**Glenelg Planning Scheme Draft Amendment C107gelg
Cape Bridgewater Residential Hotel Resort**

Priority Projects Standing Advisory Committee Report – Referral No 10

Draft Glenelg Planning Scheme Amendment C107gelg

Residential Hotel Development at Cape Bridgewater

Figure 9 Cut and fill 'heat map' - amended

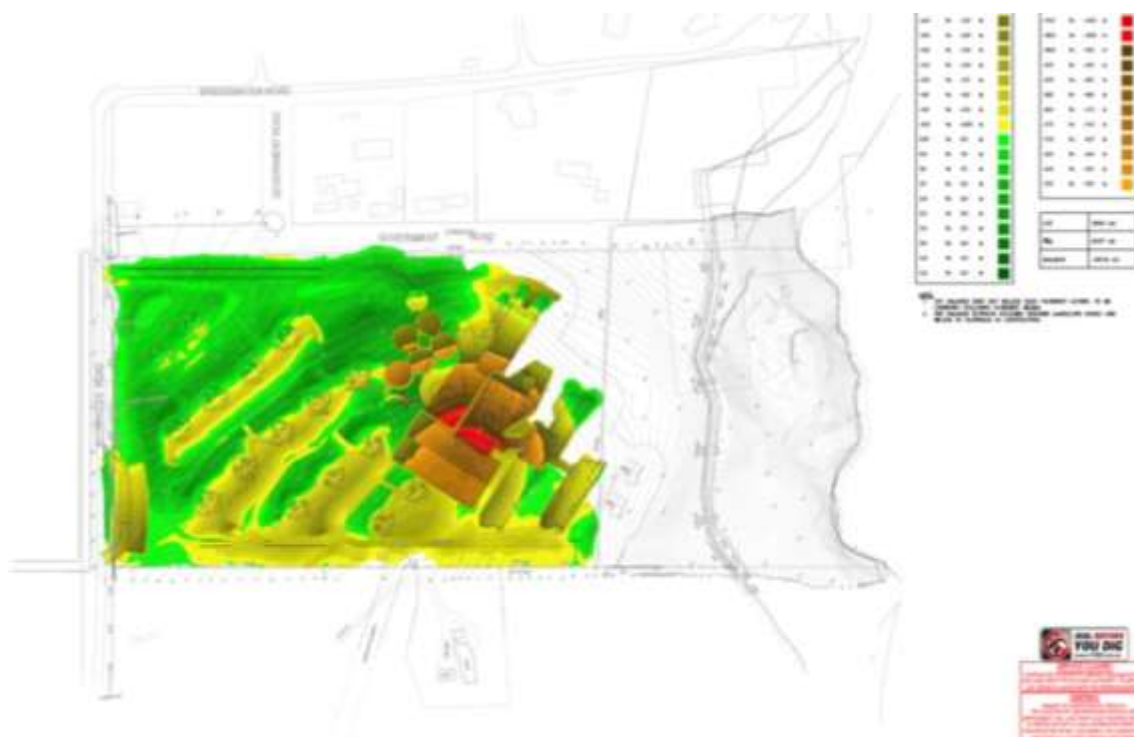
A significant amount of earthworks is proposed. Figure 9 contains the cut and fill heat map and Table 1 shows an earthworks comparison between the original and amended set of plans.

Under the amended design the hotel buildings and associated carpark require a site excavation of up to 11.5 metres in depth. This indicates approximately 33,740 cubic metres of spoil from the land would need to be disposed of off-site. However, the amended plans show rammed earth buttresses to the hotel complex of buildings and the Committee was advised there should be no need to export spoil from the land as it would provide material for these structures. To gain an understanding of the extent of cut and fill, a comparison has been made to Olympic swimming pools³. The Applicant advised the intent was to set the building bulk within the landscape and not upon it.
